Smithsonian Institution

Revitalization of the Historic Core
(RoHC)

Revised Concept Review
Submission

U.S. Commission of Fine Arts
17 February 2022

EAST RANGE 4TH FLOOR CORRIDOR – EXISTING CONDITIONS

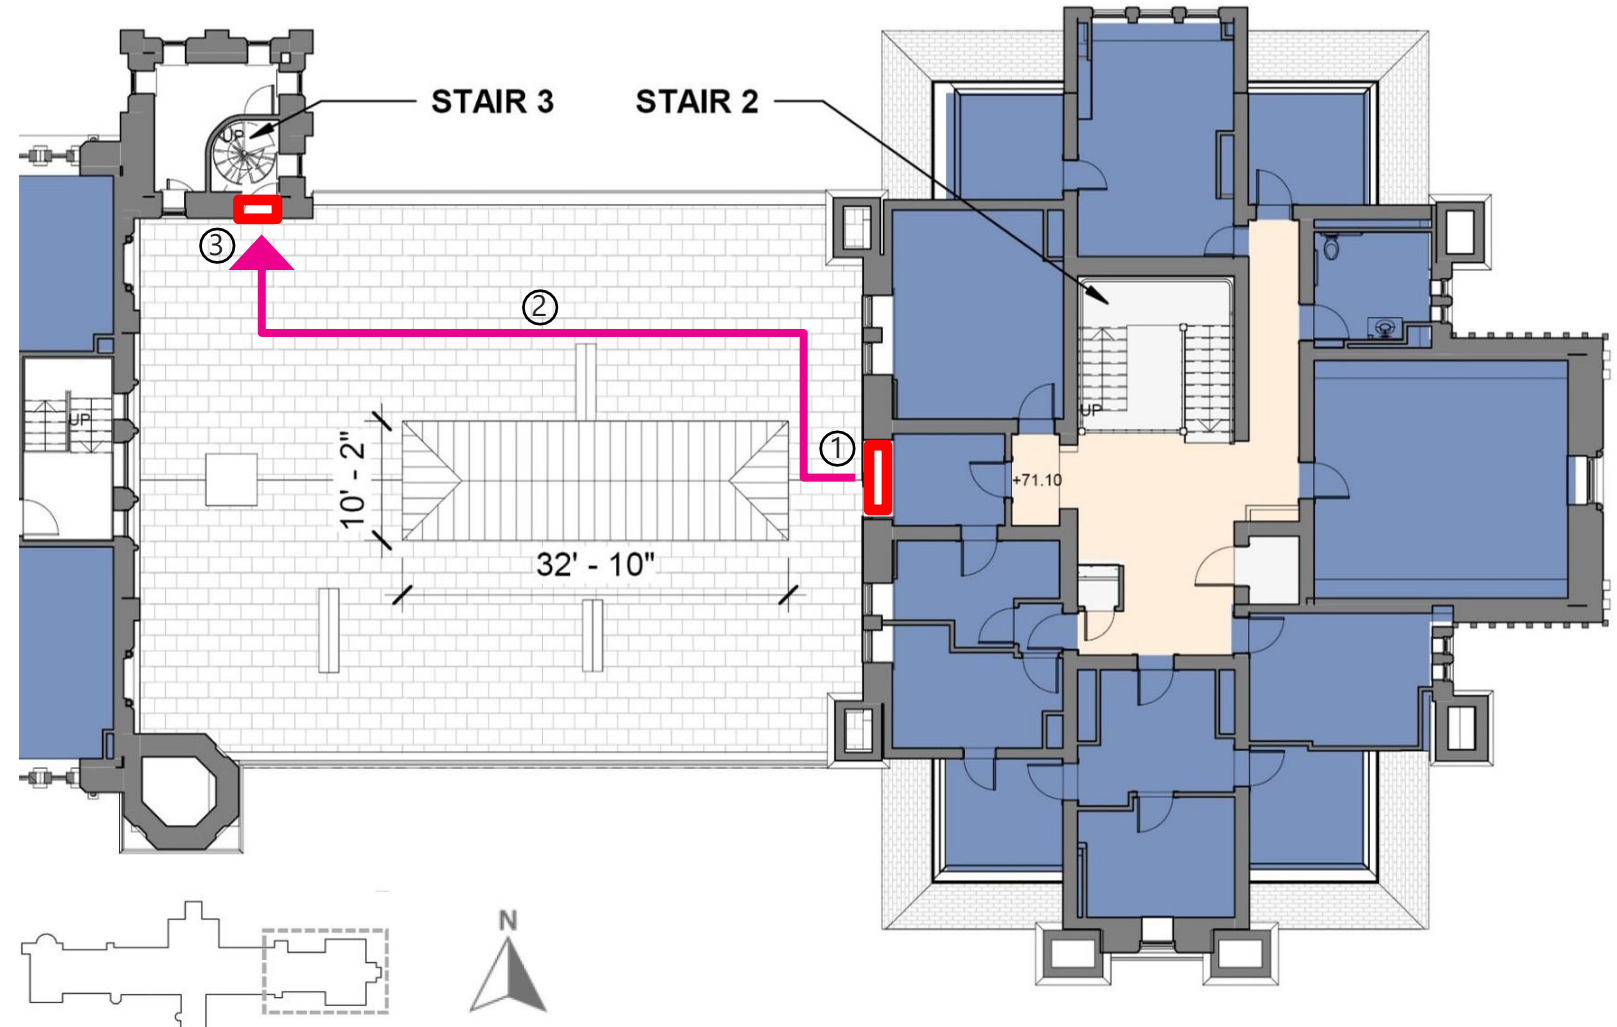
Castle- East Wing 4th Floor Egress

- Strongly questioned the design of the large connecting monitor structure on the roof of the East Range
- Suggested further study to minimize the size of the connector, possibly cladding it entirely in copper
- Possible alternate to find a location within the existing building to accommodate the necessary egress

AREAWAYS – PROPOSED SECTIONS

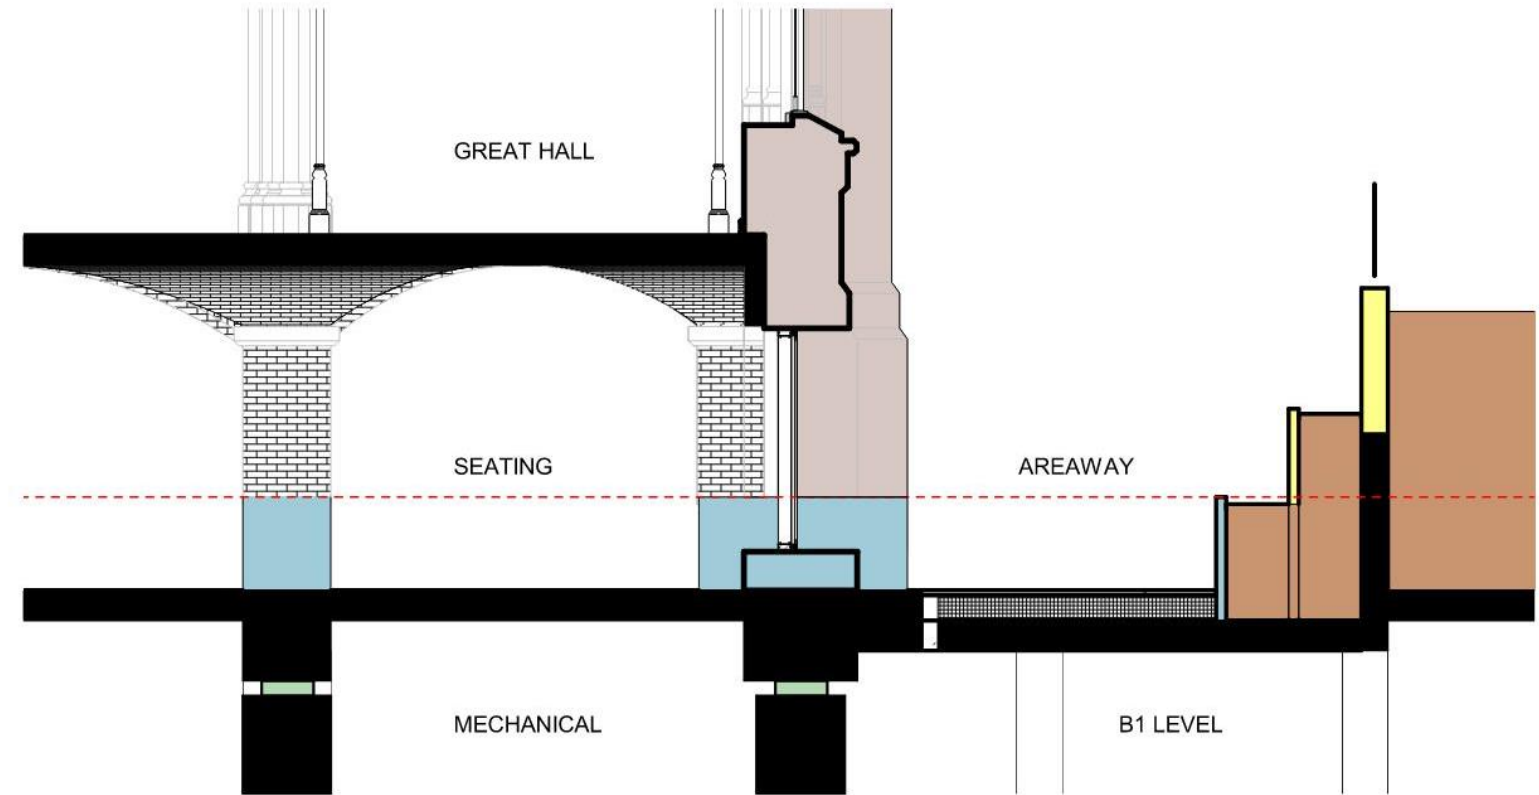
Castle- Areaway Finish Treatment

- Requested further consideration of how the new areaway walls would be finished, both in the building yard and above the building's new foundations

- The floor of the areaway is the roof of the new B1 level below grade.
- Areaway retaining wall flush or stepped.
- Railings for fall protection.
- Daylight studies will be done to show the impact of natural light in the basement.
- Seismic joint is conceptually incorporated into the areaway wall – there are a variety of ways to integrate and conceal the joint that will be studied in future phases.

PROPOSED COOLING TOWERS

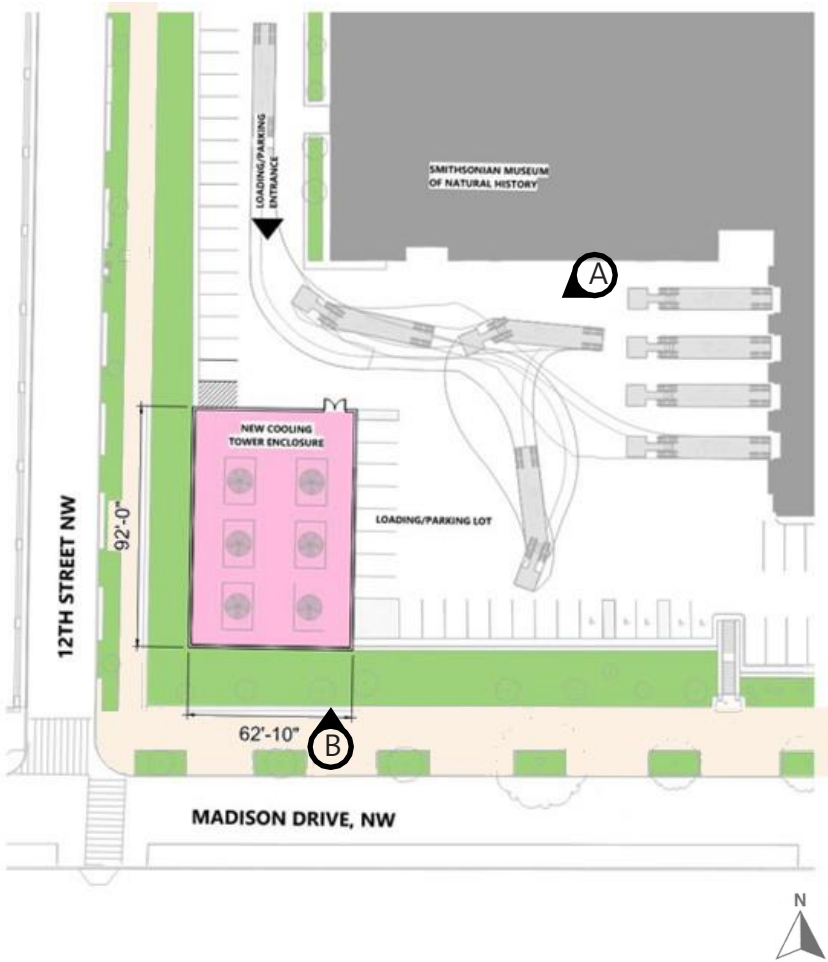
Cooling Towers

- Requested more information about the design
- Recommended that this environmental strategy needs to be considered more carefully in the context of the sustainable planning for the Mall

AFRICAN ART MUSEUM PAVILION FOUNTAIN GARDEN

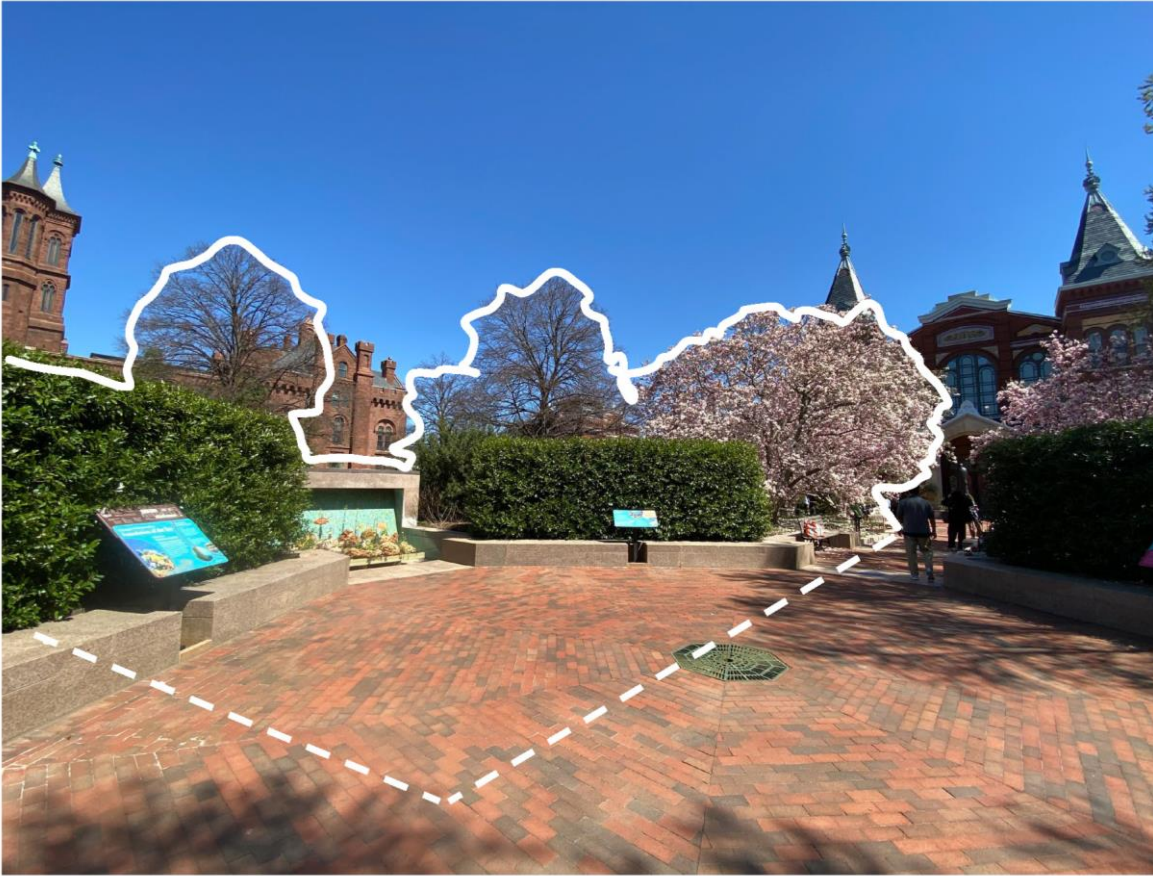
Landscape- Fountain Garden in Haupt Garden

- Recommended further study of the design for reconstructing the fountain garden

- Carefully document Fountain Garden hardscape and water features; salvage and rehabilitate after insertion of CUP
- Replace existing vegetation in the spirit of the existing character while accommodating new below-grade improvements

ACCESSIBILITY IMPROVEMENTS – SIB SOUTH ENTRANCE

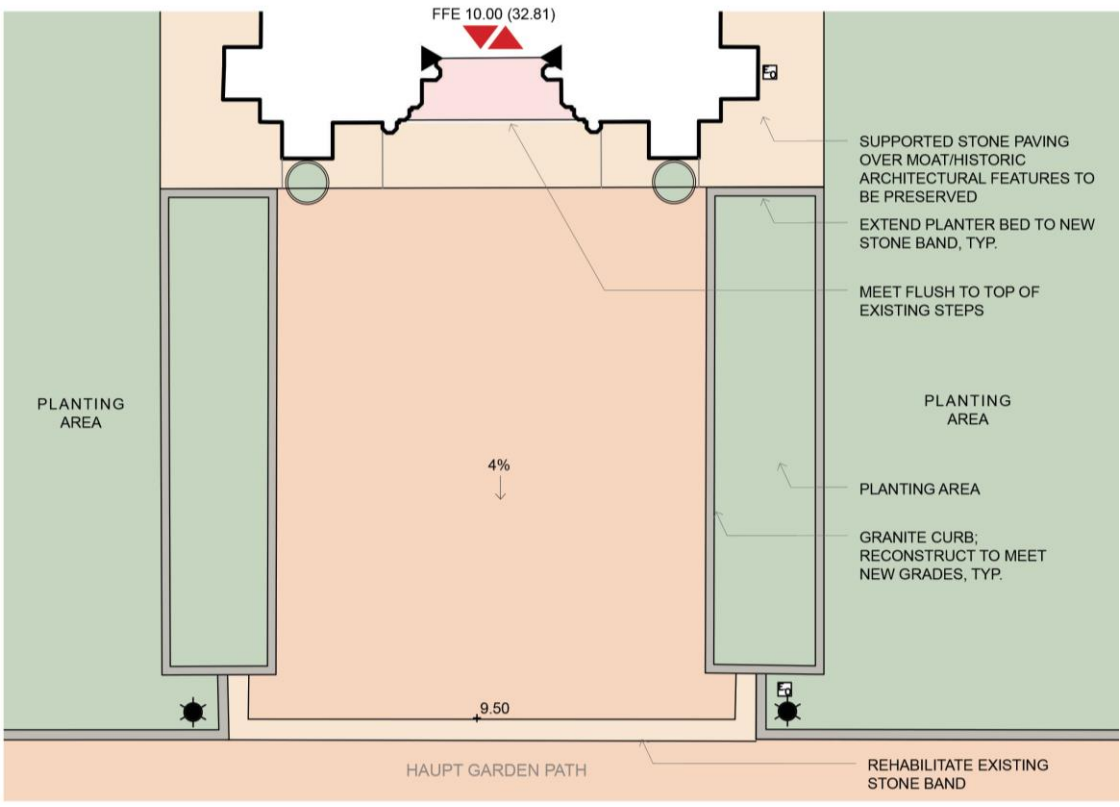
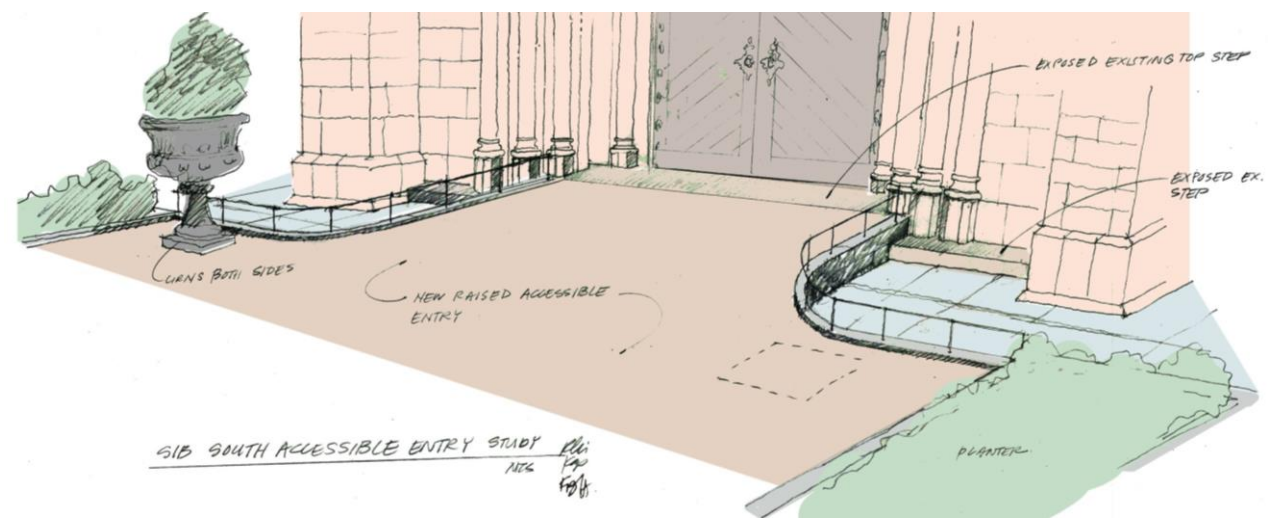
SIB- South Entrance Accessibility

- Noted that the ramps and landing on Independence Avenue would create an undesirable constrained condition in the public sidewalk - recommended refining the design to limit the impact on public space while creating a welcoming entrance
- Suggested that the composition of other elements- streetlights and trees- may help to make an appropriate frame for this entrance
